PERFORMANCE SPECIFICATION

RESISTORS, VARIABLE, COMPOSITION, STYLE 2RV7

This amendment forms a part of MIL-R-94/6C, dated 19 June 1985, and is approved for use by all Department and Agencies of the Department of Defense.

FLATTED SHAFT

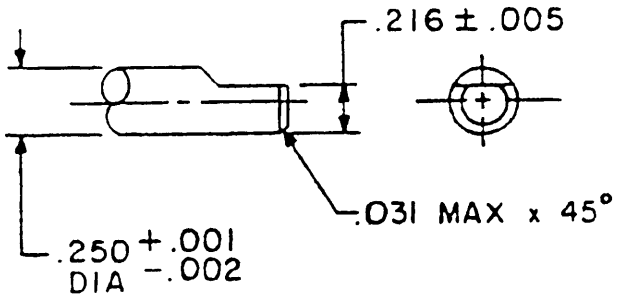
FIGURE 1, add the following drawing to figure 1:
